Office Action Summary

10/553,568

PHILIPPE, NOELLE

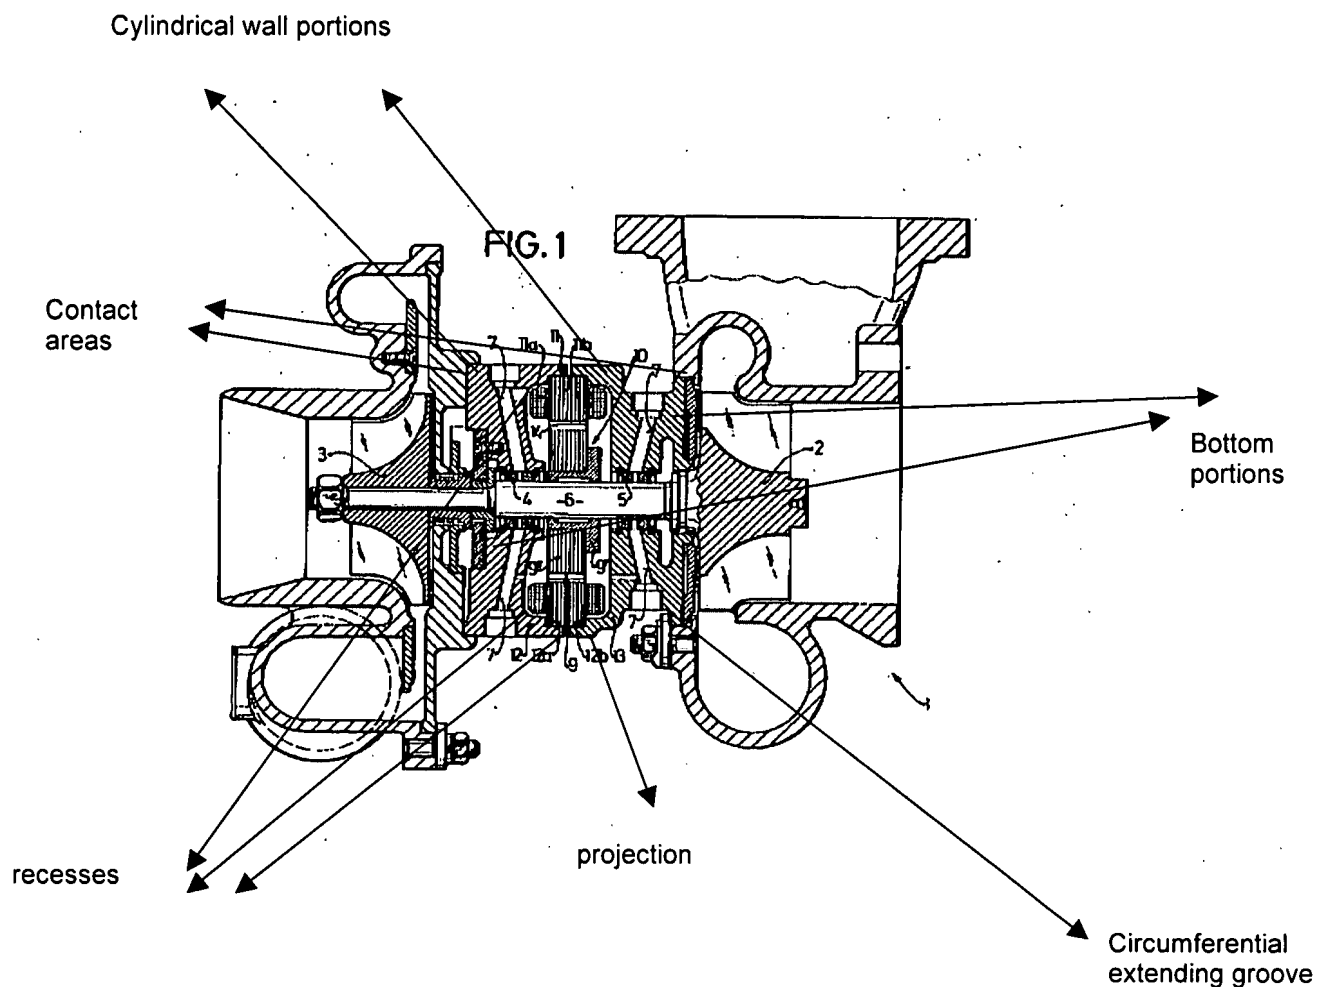
wherein at least one of the cartridge housing portions (12, 13) is provided with at least one recess portion (Not Numbered) formed at the inner side of the axial end portion of the cylindrical wall portion (Not Numbered) which extends at least partially in the circumferential direction of the cylindrical wall for receiving a projection (Not Numbered) of the stator (11);

wherein each cartridge housing portion (12, 13) is provided with one recess portion (Not Numbered), wherein the recess portions (Not Numbered) are symmetrically to a plane defined by the abutting tips of the cylindrical wall end portions;

wherein at least one of the bottom portions (Not Numbered) is formed at least partly concave inwardly;

wherein at least one contact area (Not Numbered) is formed at each of the cartridge housing portions (12, 13) so as to be in contact with respective counter contact areas of two housings (Not Numbered) between which the cartridge is fittable;

wherein in at least one of the cartridge housing portions (12, 13) a circumferentially extending groove (Not Numbered) is disposed so as to receive an o-ring for sealing between

the cartridge housing (12, 13) and one of the two housings (Not Numbered) between which the cartridge (12, 13) is fittable;

wherein cooling slits and an integrated piping (via 7) for motor cooling is integrated in at least one of the cartridge housing portions (12, 13) (See Figure 1, Column 3, lines 1-68, Column 4, lines 1-31).
